***MAJOR PROJECT ASSESSMENT
Redevelopment of UNSW College of Fine
Arts (CoFA) Campus, Paddington***

Director-General's Environmental Assessment
Report
Section 75I of the
Environmental Planning and Assessment Act 1979

(Prepared by City of Sydney Council under Instrument of
Delegation dated 6 June 2008)

December 2008

Figure 21. Dotted outline illustrates permissible envelope under DCP and grey shaded area represents breach of envelope for Building F

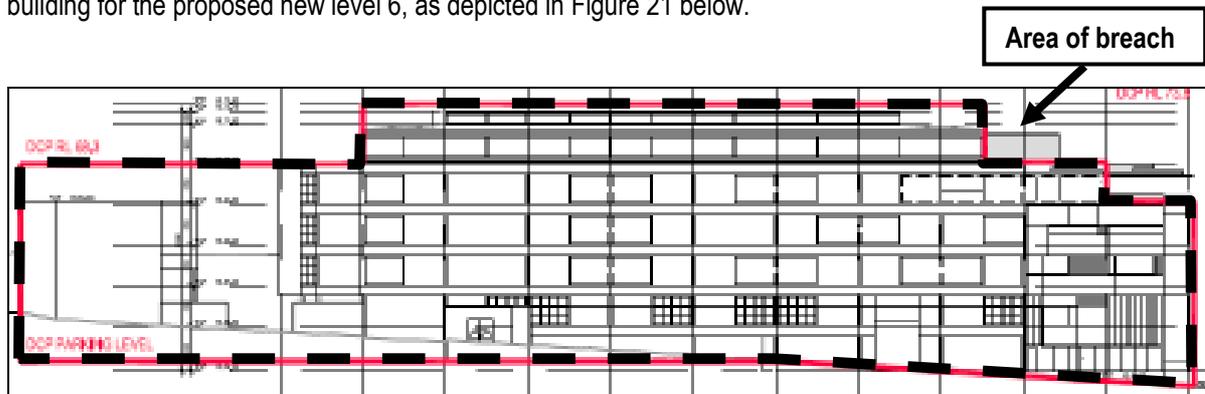
The provisions of the South Sydney DCP 1997 Amendment Part G: Special Precinct No. 8 – University of New South Wales Paddington Campus, provide specific building envelopes within which any proposed buildings on the site must be contained. The proposed alterations and additions to Building F result in a minor breach to the northern end of the envelope of approximately 2m at level 6, to enable a connection to an existing stair in the building for the proposed new level 6, as depicted in Figure 21 below.

The proposed breach is minor in nature and does not result in any adverse impacts upon the surrounding area. The additional floor area is required to ensure the functionality of the building and does not result in any significant increase to the bulk and scale of the building. Accordingly, variation to the building envelope for Building F is supported in this instance.

Figure 23. LEP 1998 Heritage Map

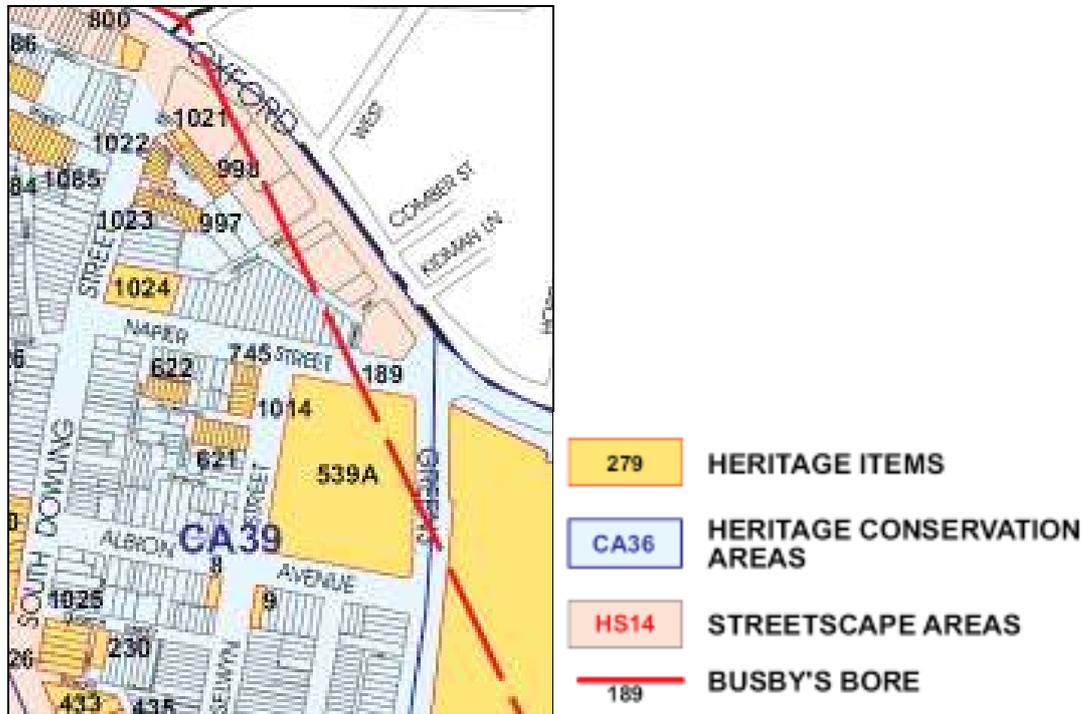
The image in Figure 23 illustrates the general location of Busby's Bore as it passes underneath the site. The Bore passes underneath the existing Building F. The proposal includes approximately 1m of excavation under the northern part of Building F, approximately above the Bore. Given the potential close proximity of the proposed excavation to Busby's Bore, it is necessary that an Archaeological Assessment be carried out by a suitably qualified consultant which identifies the exact location and depth of the Bore below the surface, the potential impacts of the proposed excavation and construction of the new slab underneath Building F, and measures to mitigate any impacts should they be identified. With respect to the significance of Busby's Bore as a State Heritage item, it is recommended that this requirement form the basis of a Deferred Commencement condition to be satisfied prior to the activation of any consent.

Figure 24. Floor plan and western elevation of Building D illustrating light wells

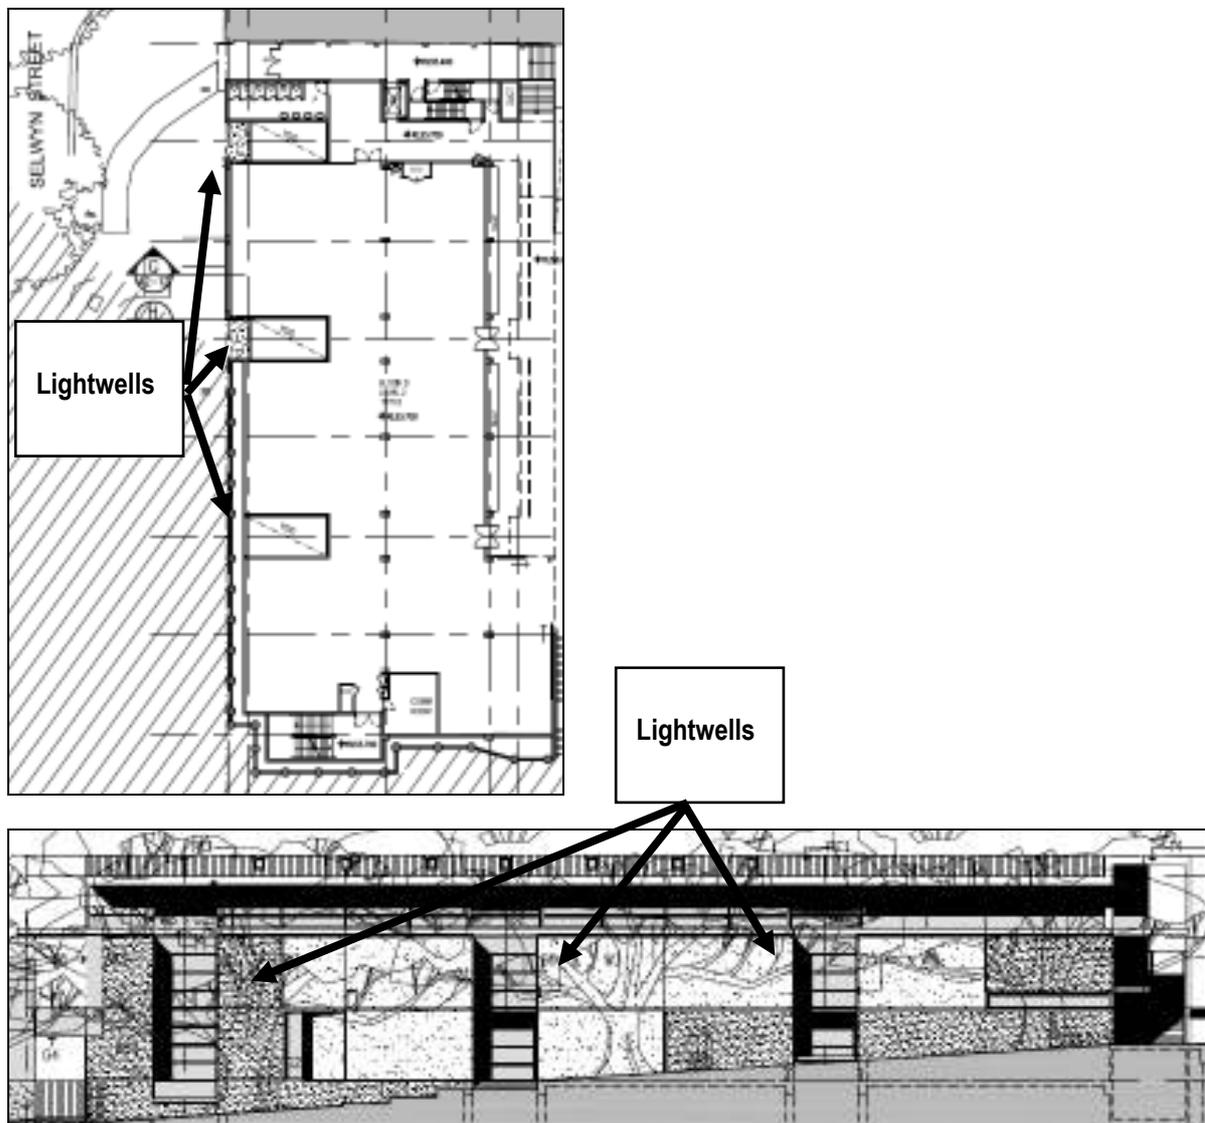
Building D has been designed so that it has three large glass 'indents' or cross-sectional elements. These 'indents' act as light-wells to the levels of Building D below natural ground level and provide natural light to the above ground levels 1, 2 and 3 in a manner which greatly minimises outlook to Selwyn Street and protects the privacy of the residents. The remainder of the western elevation of Building D is characterised by coloured rendered masonry wall.

The design of the western façade of Building D is considered an appropriate response to the need to ensure privacy to the residents in Selwyn Street, provision of natural light to the building, and architectural interest to the western façade of Building D. It is considered that the proposal does not result in any unreasonable privacy impacts to the adjoining residential properties.
